PROJECT:  
STAGE 5 - CLUB EXTENSION

PROJECT:  
STAGE 5 - CLUB EXTENSION  
PHASE 2 WORKS - SOUTHERN  
CARPARK & ENCLOSURE

DRAWING TITLE:  
PROPOSED ELEVATIONS

SECTION 96

DRAWING TITLE:  
PROPOSED SECTIONS

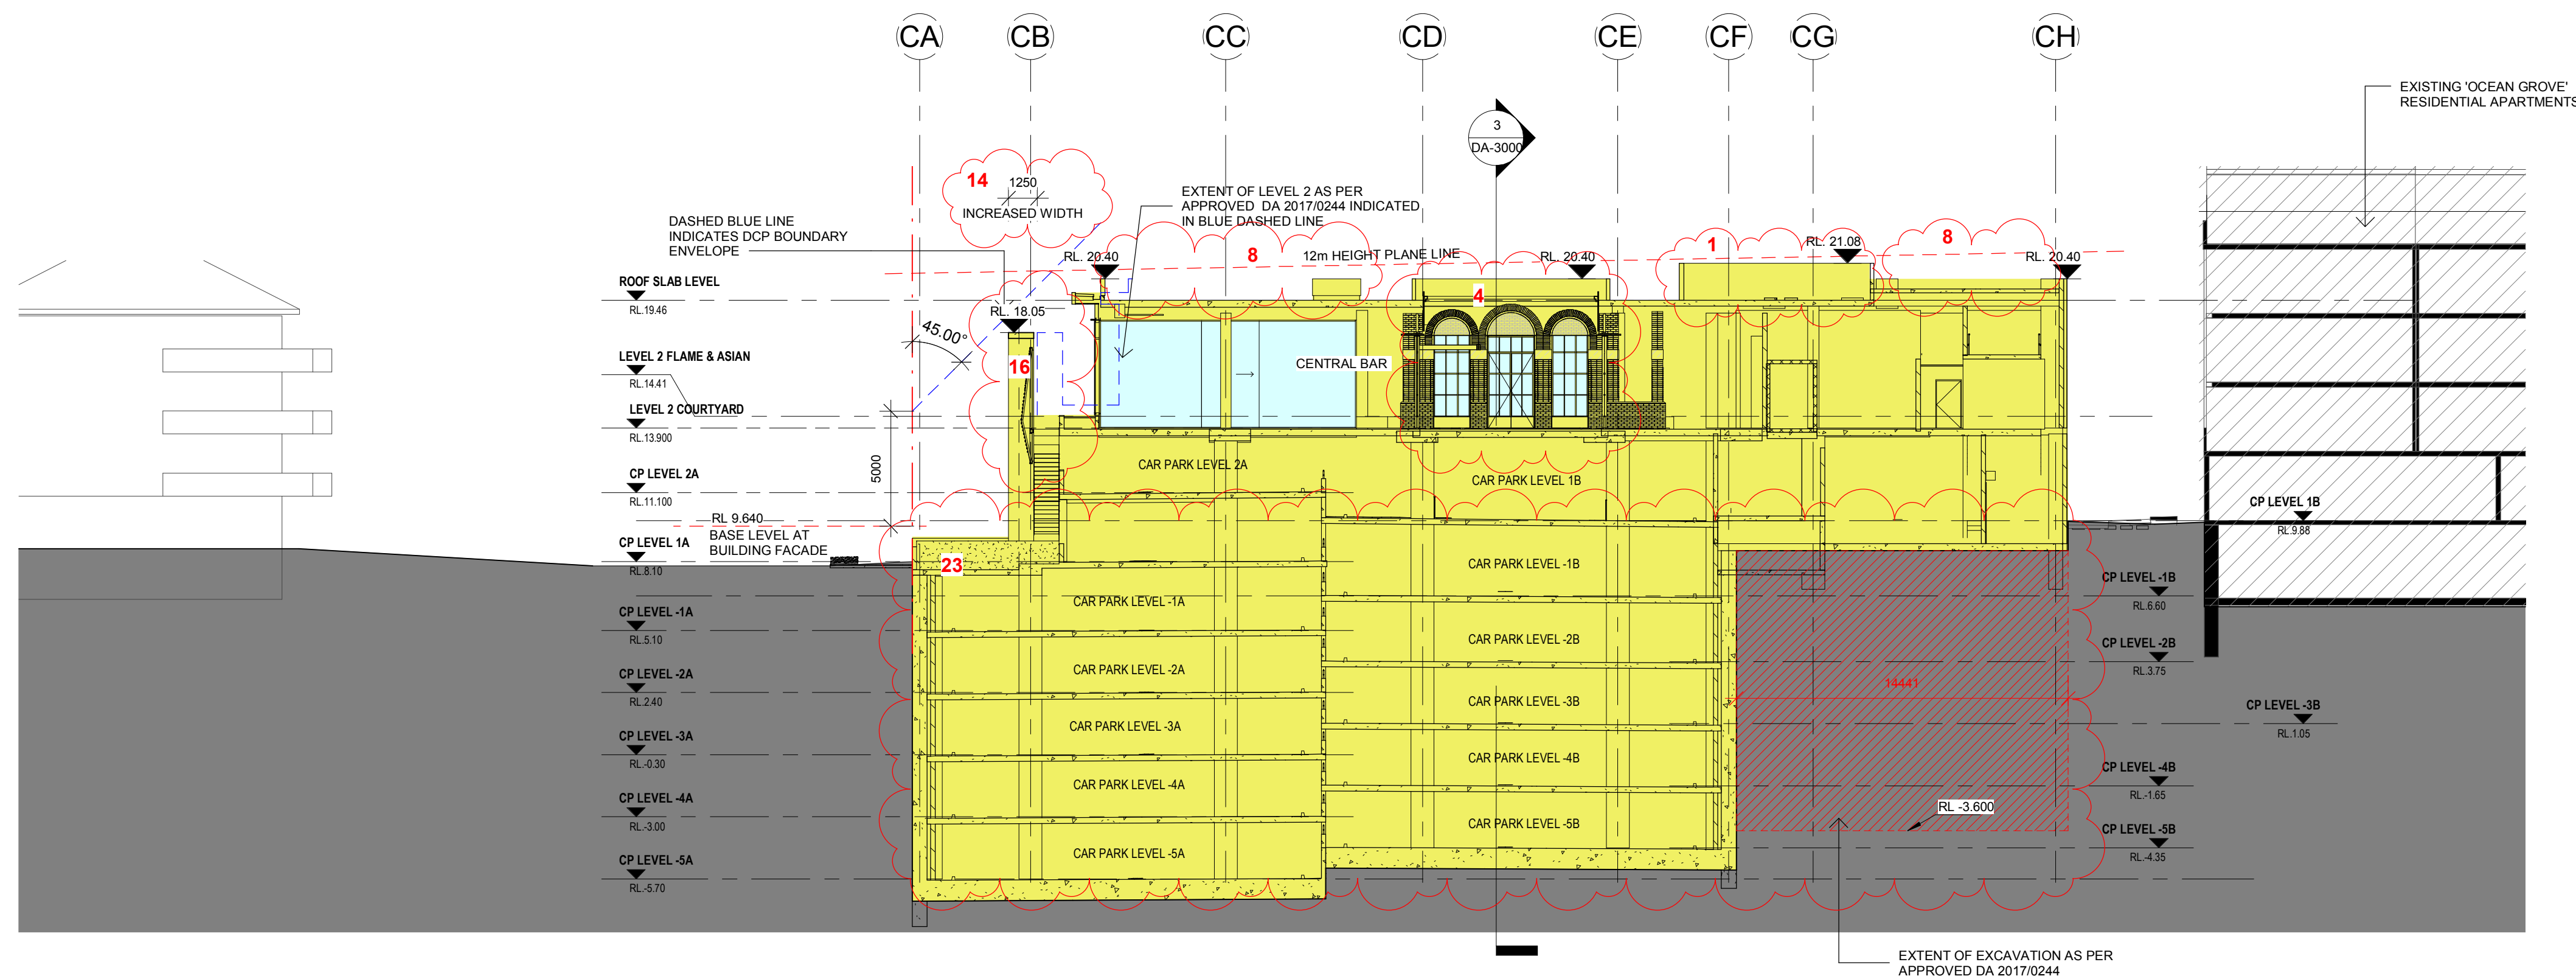
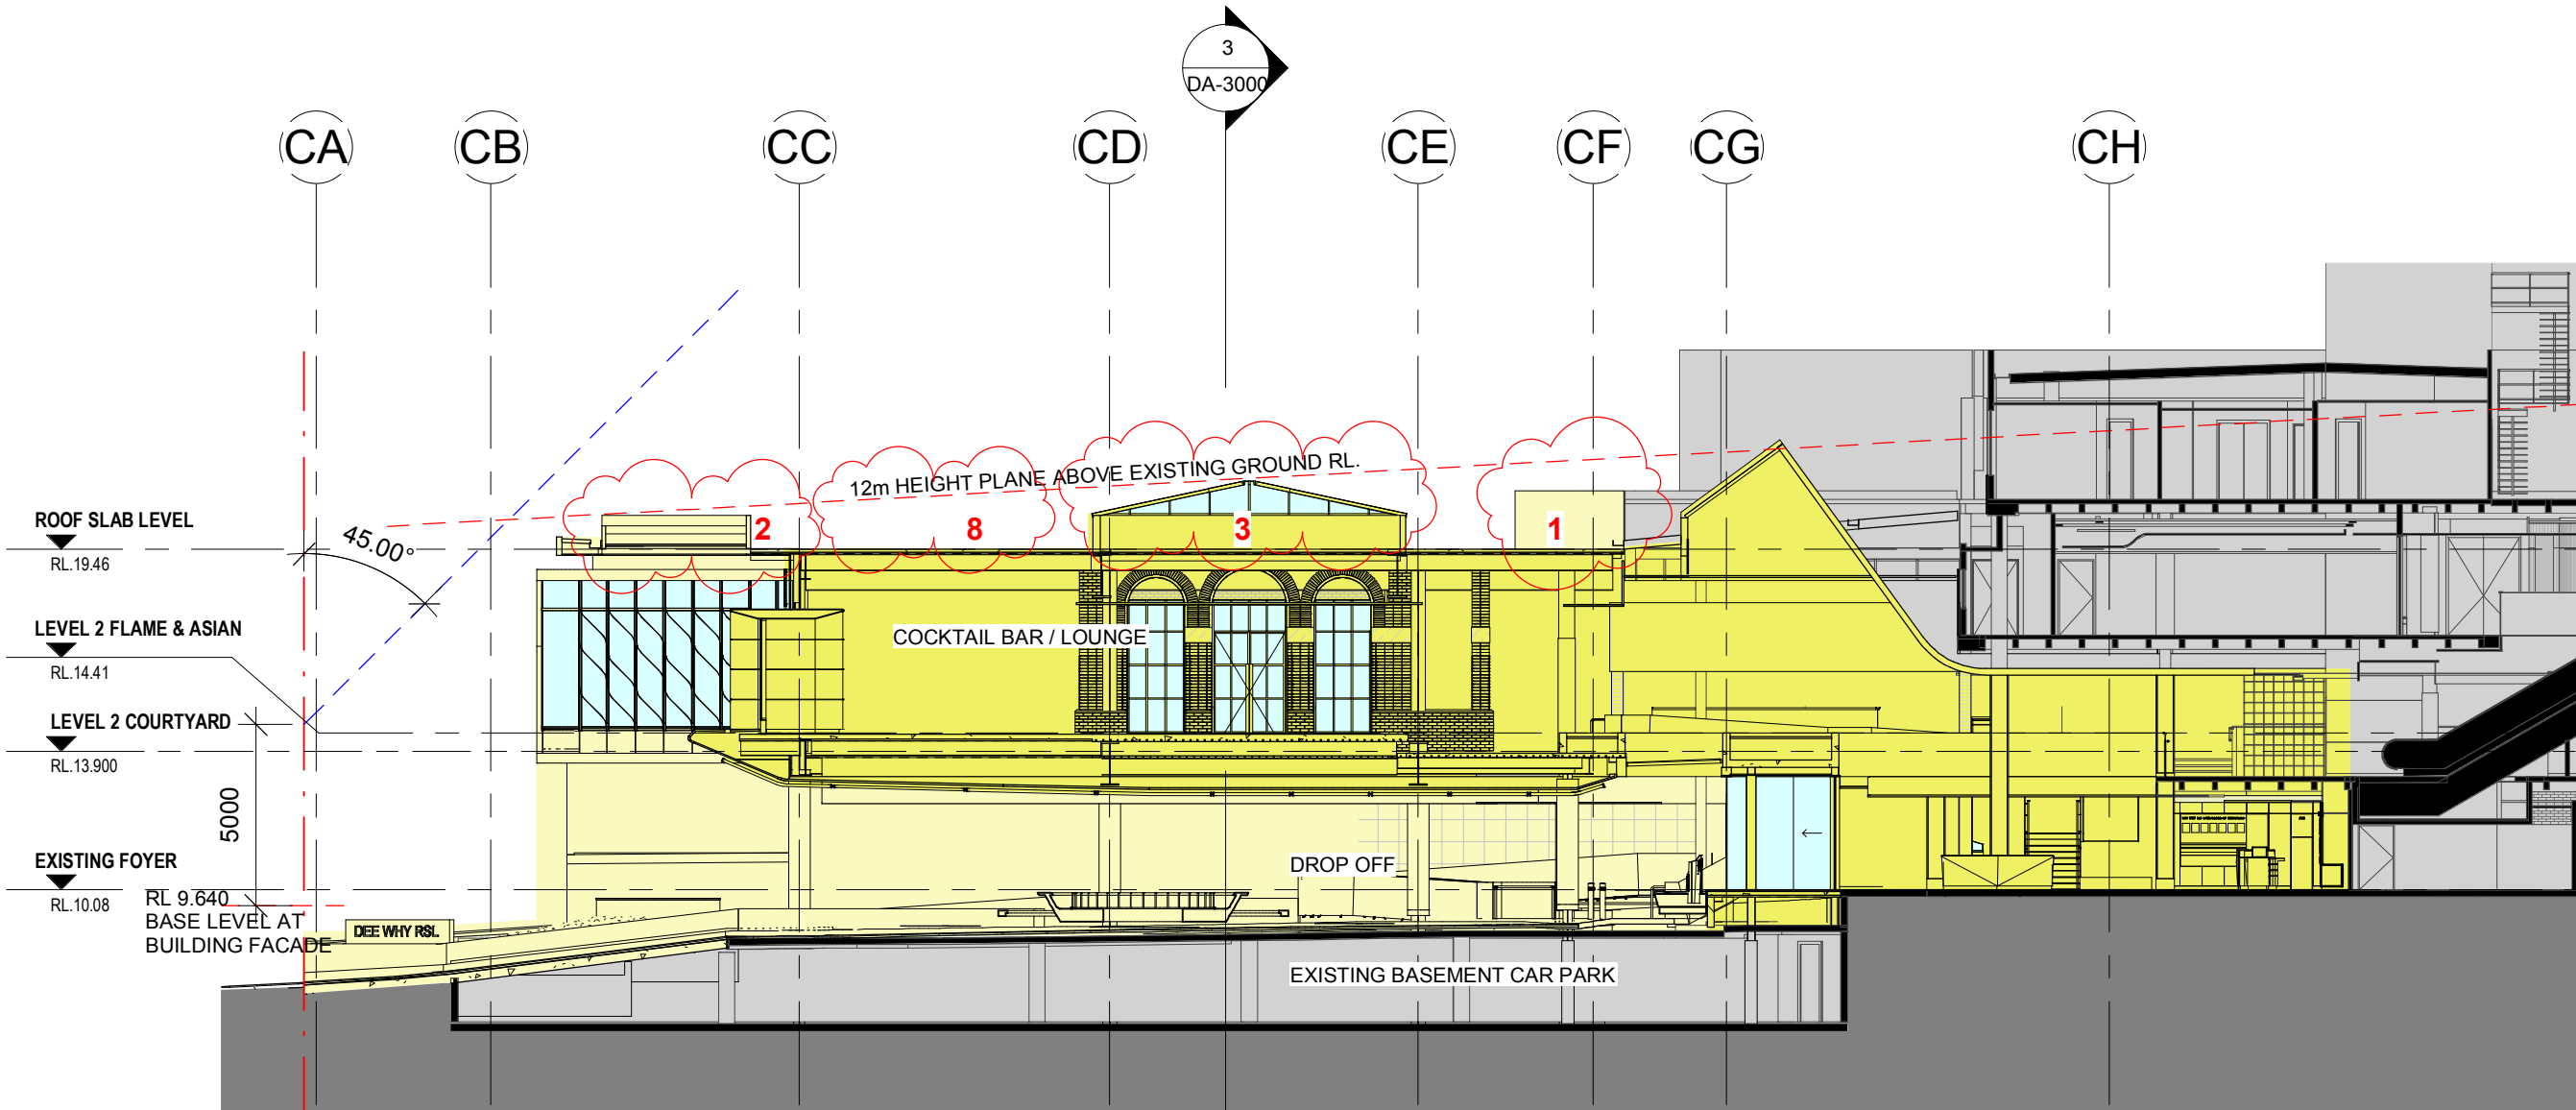
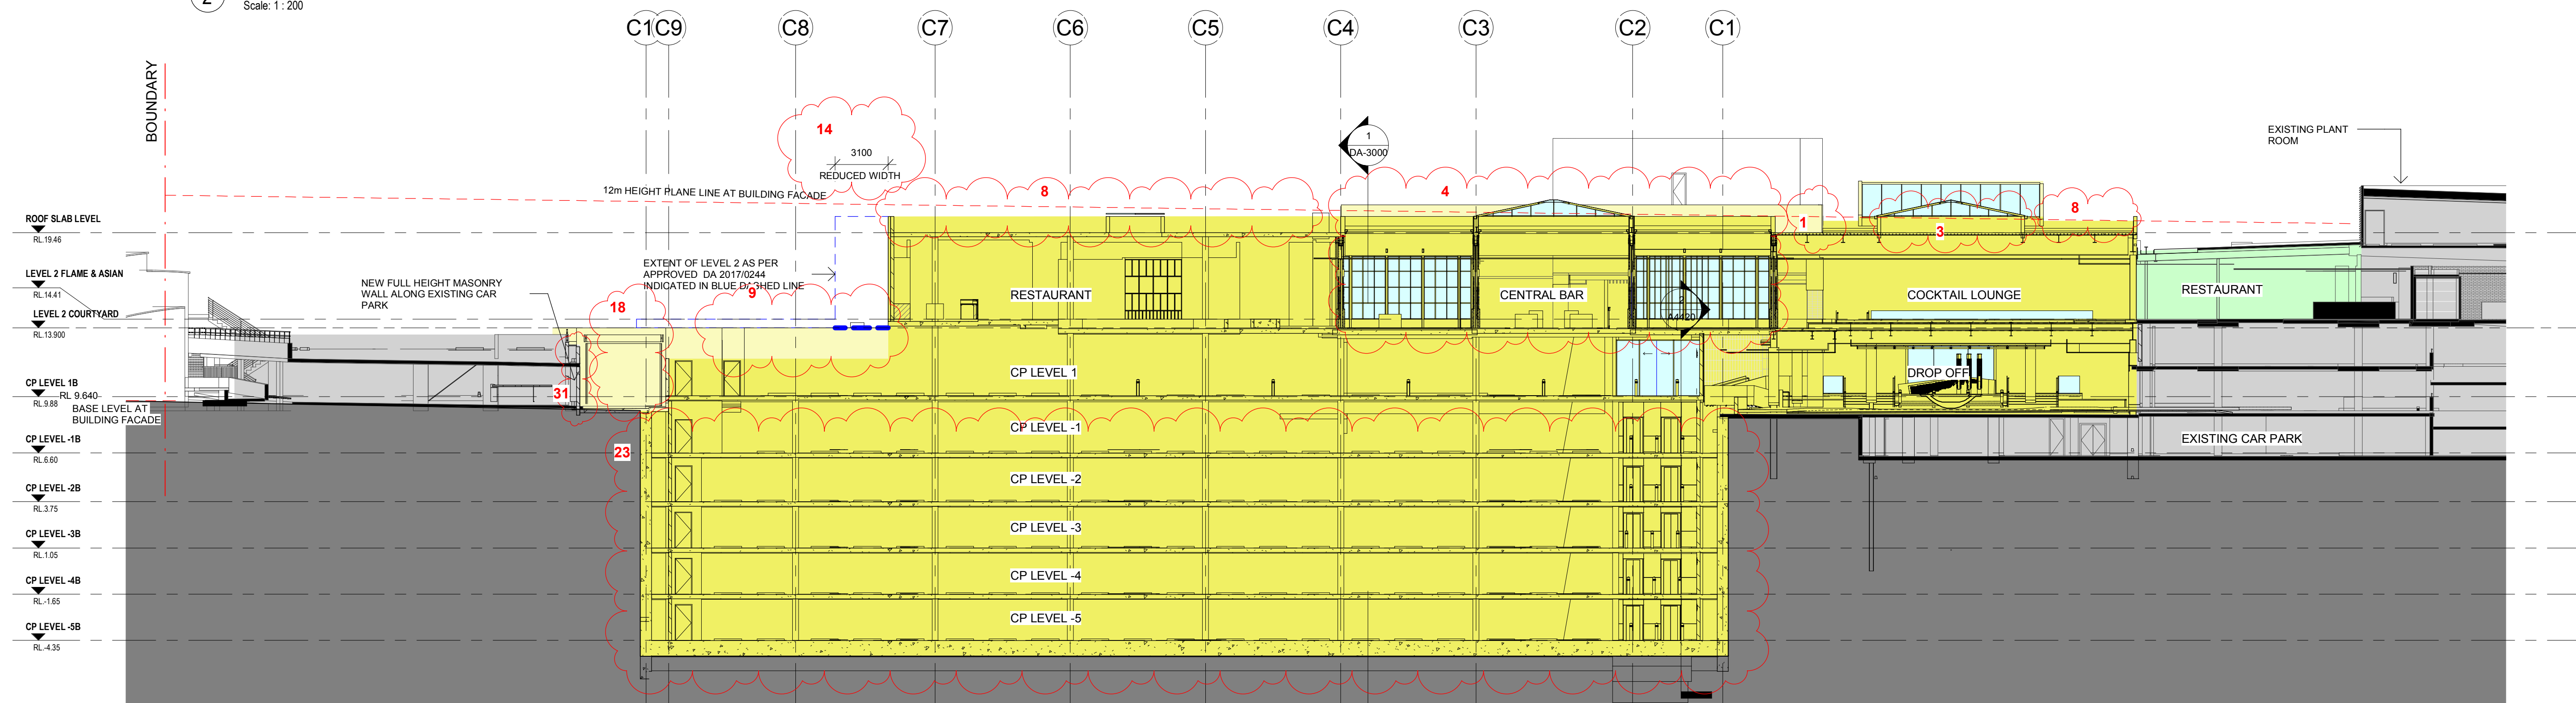
- CHANGES FOR SECTION 96 APPROVAL
1. RELOCATED OPEN PLANTROOM AT THE ROOF LEVEL
  2. MODIFIED ROOF OPENING ABOVE MAIN ENTRANCE
  3. MODIFIED CENTRAL SKYLIGHT (REDUCED HEIGHT, MODIFIED PITCH)

4. MODIFIED COURTYARD: TWO OPEN COURTYARDS AND ONE SKYLIGHT COVERED AREA INSTEAD OF ONE LARGE GLASS ROOF. REDUCED HEIGHT AND PITCH
  5. MODIFIED SMOKING TERRACE: ROOF OPENING, SIZE AND PLANTED AREA. AREA REDUCED BY 21m<sup>2</sup>

6. REDUCED NUMBER OF ROOF SKYLIGHTS ABOVE ASIAN RESTAURANT: 2 INSTEAD OF 6 TO SUIT THE NEW INTERNAL LAYOUT
  7. MODIFIED EXIT STAIR: POSITION, CONFIGURATION, METAL ROOF NO LONGER REQUIRED

8. CONCRETE ROOF INSTEAD OF METAL DECK ROOF FOR THE MAJORITY OF THE BUILDING EXTENSION
  9. NO SLAB ABOVE THE EXPOSED CAR PARK LEVEL 2 IN THE SOUTH AREA

10. NEW ACOUSTIC METAL ROOF ABOVE REVISED LOADING DOCK
  11. MODIFIED FACADE APPEARANCE DUE TO CHANGES IN THE CAR PARK LEVELS, LOADING DOCK AND EGRESS STAIRS

12. REMOVED LOUVRES ON THE BACK FACADE (WESTERN FACADE) DUE TO MECHANICAL RISER NO LONGER REQUIRED / REVISED LOCATION FOR EGRESS DOORS
  13. 2m WIDE INTERNAL EGRESS STAIR MODIFIED INTO TWO 1m WIDE EXTERNAL STAIRS WITH DECORATIVE BALUSTRADES

14. EXTENT OF LEVEL 2 (MAIN TRADING LEVEL) REDUCED BY 8326mm FROM THE SOUTHERN BOUNDARY AND INCREASED BY 1100mm TO THE EASTERN BOUNDARY
  15. MODIFIED FACADE CURTAIN WALL MULLION BLADES

16. CONCRETE BLADE WALL REDUCED BY 1.47m IN HEIGHT AND 6.2m IN LENGTH
  17. VERTICAL FINIS REMOVED FROM BACK WALL (WESTERN FACADE)
  18. REVISED LOADING DOCK ENTRANCE AND LOCATION/ ENLARGED DEMOLISHED AREA IN THE EXISTING RETAINED SOUTHERN CAR PARK

19. NEW / MODIFIED EGRESS PATHS FROM EXISTING CARPARK LEVEL -1. NEW CARPARK LEVEL 1.
  20. RELOCATED ELECTRICAL SUBSTATION / LANDSCAPED AREA MOVED TO SUIT

21. MEDIAN STRIP ADDED AT ENTRY TO PROVIDE PLACE OF REFUGE AND ENSURE WIDTH OF ENTRY/ EXIT IS LESS THAN 8M AS PER DA CONDITION 23
  22. RELOCATED STORMWATER OVERFLOW PATH

23. EXTENT OF BASEMENT CAR PARK LEVELS REDUCED. BASEMENT REDUCED BY 14394mm FROM THE WEST BOUNDARY. BASEMENT ENLARGED BY 280mm TOWARDS THE SOUTH BOUNDARY. CARPARK CHANGED FROM FLAT PLATE TO SPLIT LEVEL ON ALL LEVELS. DEPTH OF CAR PARK INCREASED FROM RL -3.600 TO RL -5.700. OVERALL PARKING SPACES REDUCED FROM 687 TO 680

24. BASEMENT CAR PARK LEVEL -5 ADDED.
  25. CAR PARK ENTRY / EXIT MOVED TOWARD NORTH BY 3044mm
  26. PLANTER MODIFIED ON THE BACK (WESTERN) FACADE DUE TO REDUCTION OF THE MAIN TRADING FLOOR SLAB

27. LOCATION OF AIR INTAKE MODIFIED
  28. EXTENT OF RESTAURANT REDUCED BY 136m<sup>2</sup>
  29. CLUB ENTRANCE ACCESSIBLE RAMPS MODIFIED
  30. ONE ADDITIONAL EXISTING CAR PARK SPACE TO BE REMOVED FROM EXISTING NORTHERN CAR PARK

31. FULL HEIGHT SOLID MASONRY WALL ADDED BETWEEN EXISTING ZONE D CAR PARK AND LOADING DOCK ACCESS.
